**Re: Addendum No. 3
WWTP NFA Improvements
City of Conneaut**

Date: August 27, 2024

THE CITY OF CONNEAUT
WASTEWATER TREATMENT PLANT
NFA IMPROVEMENTS
ASHTABULA COUNTY
CONNEAUT, OHIO

ELECTRICAL - E SERIES
ELECTRICAL SERVICE YARD PLAN

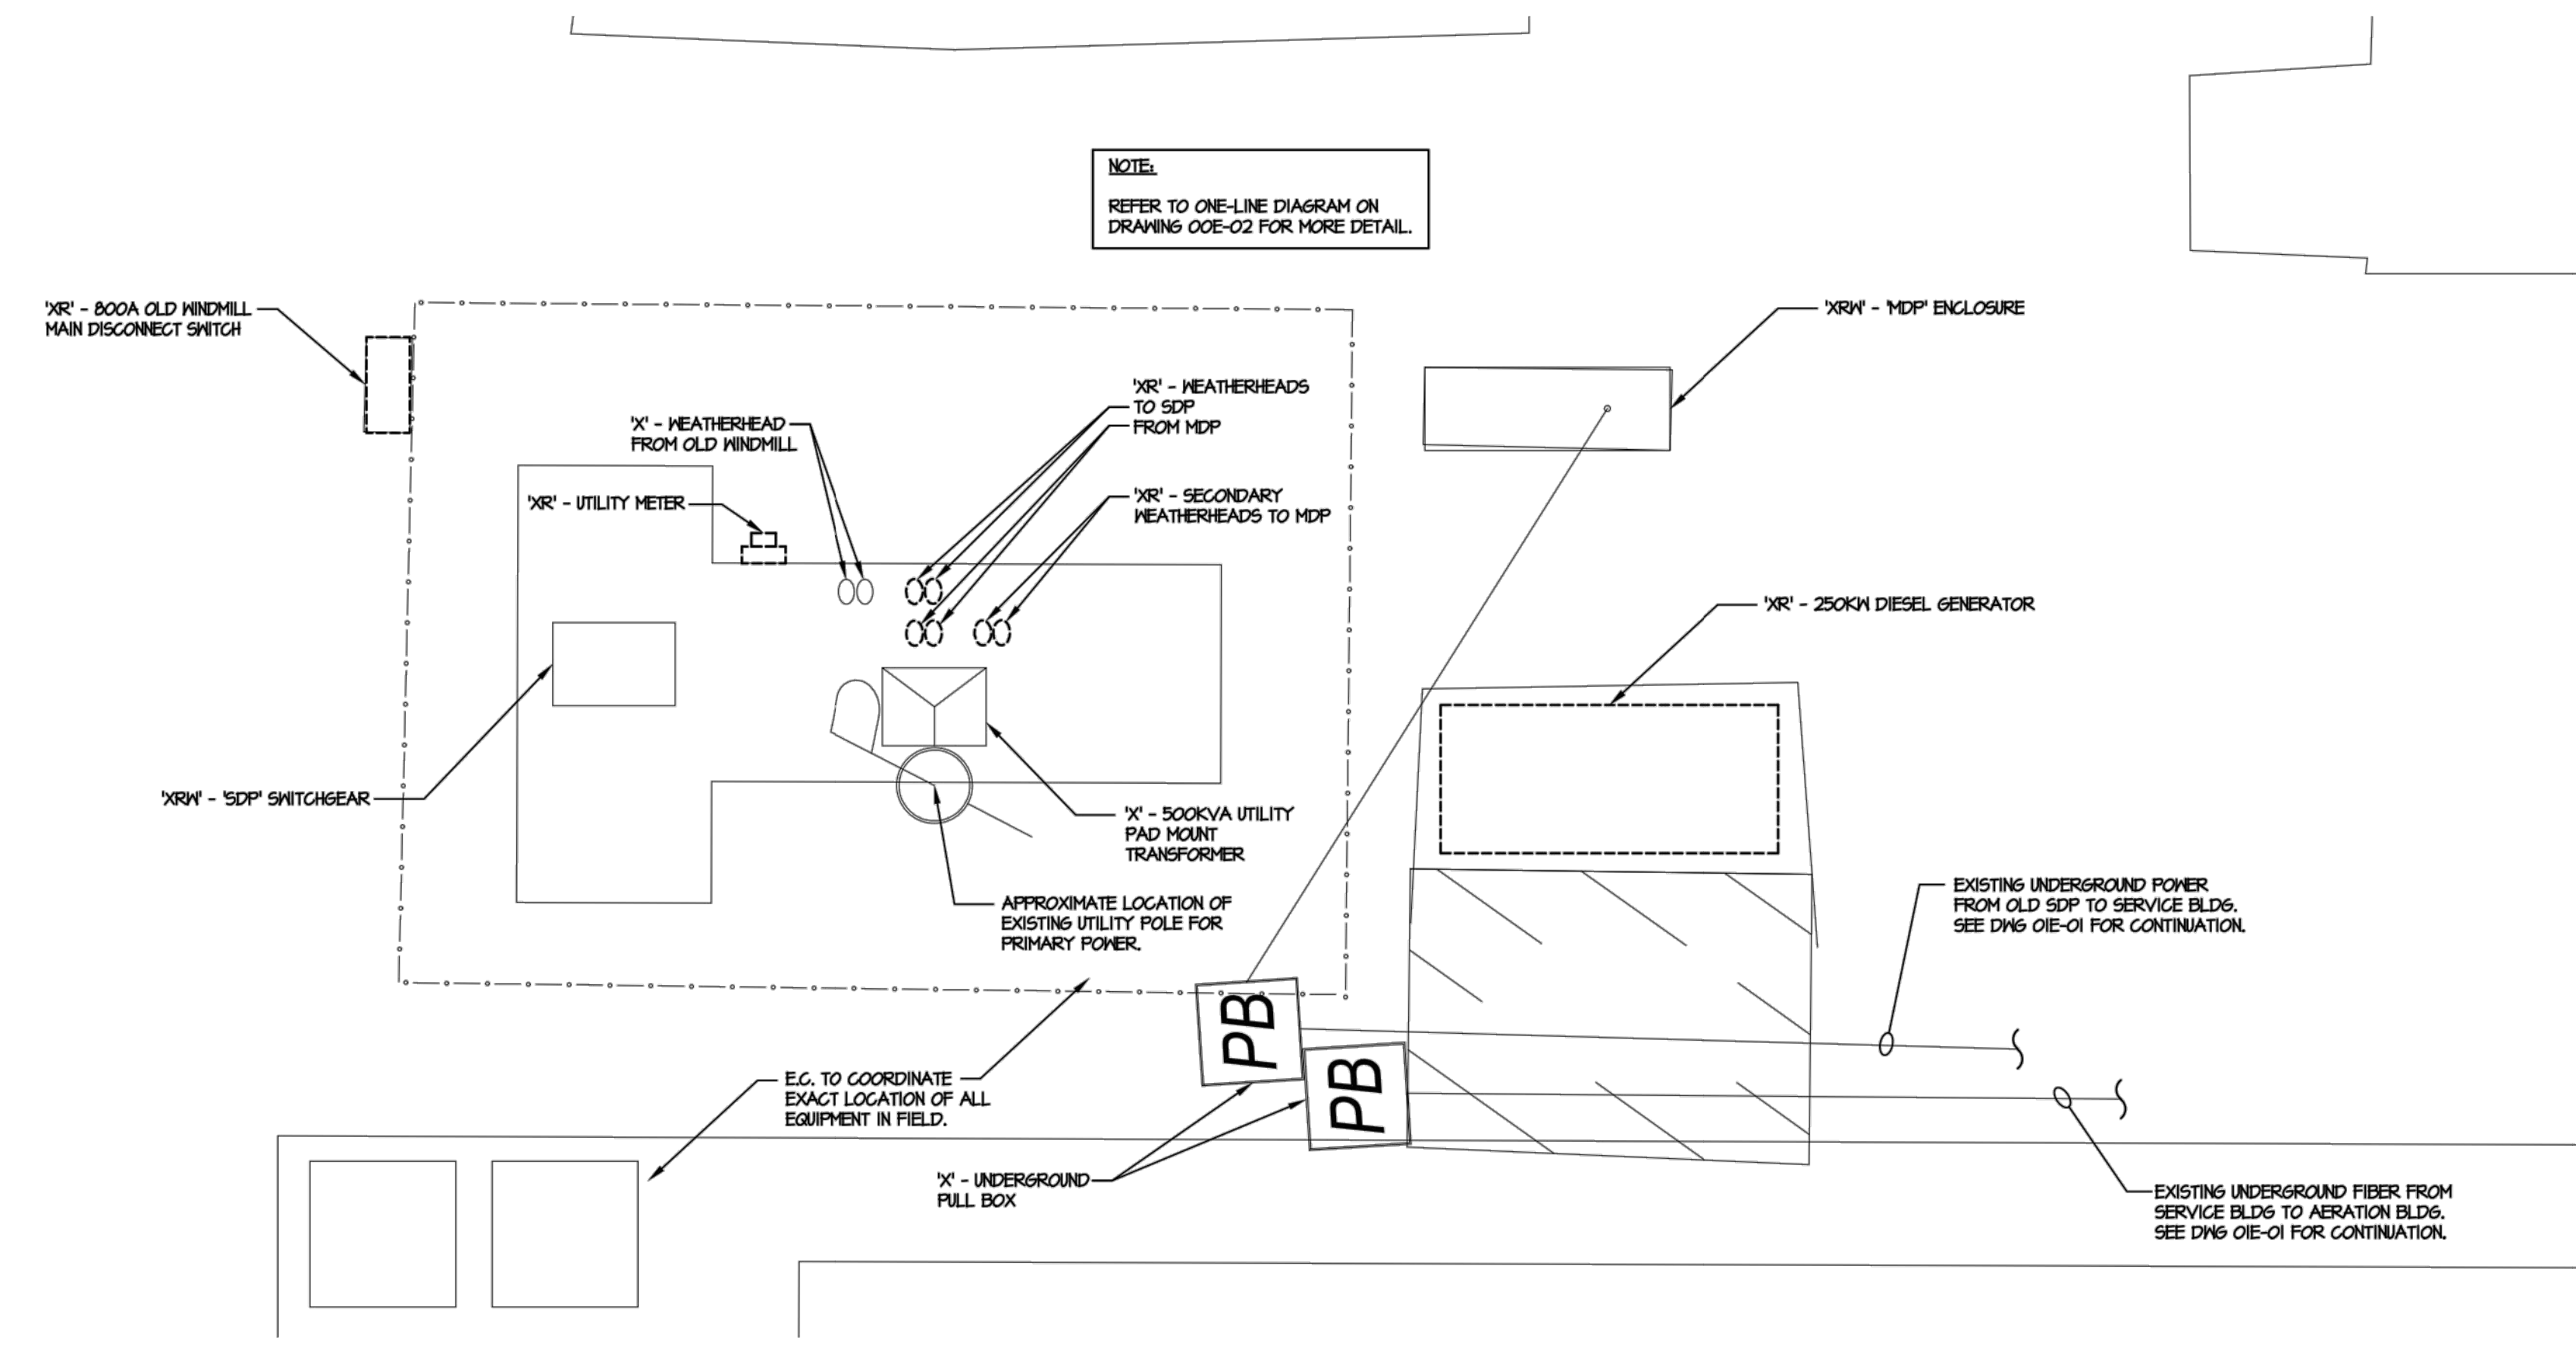
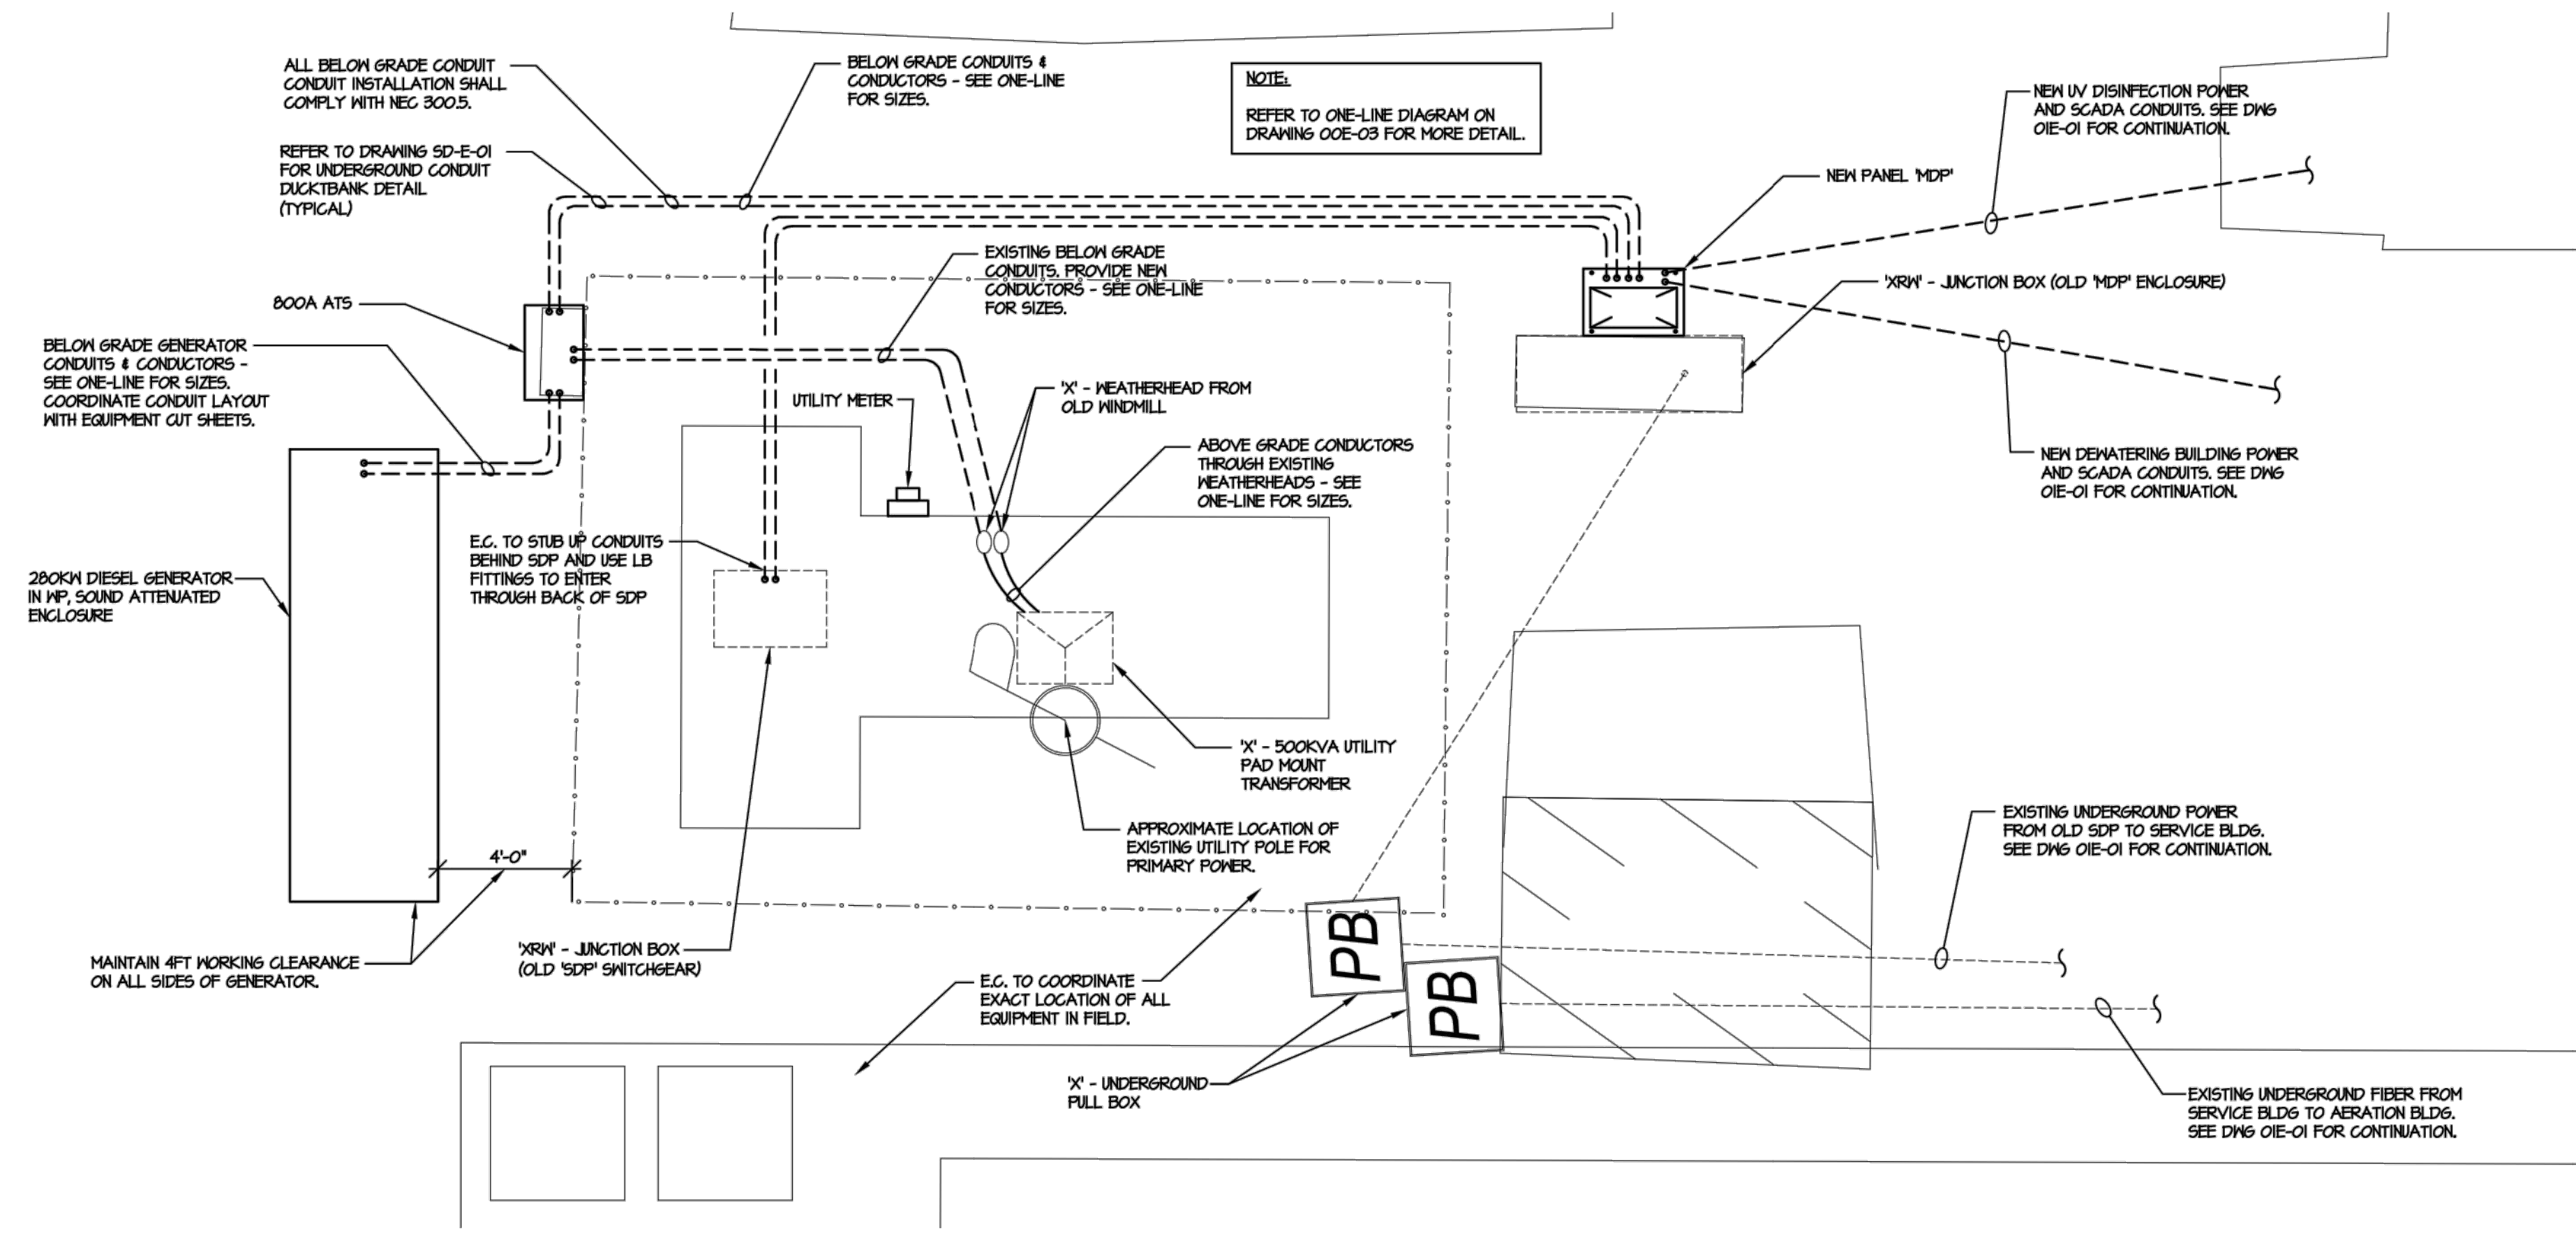
Q28. Is there a specific location for the new generator, ATS and MDP panel.

A28. See enclosed 01E-02 plan sheet.
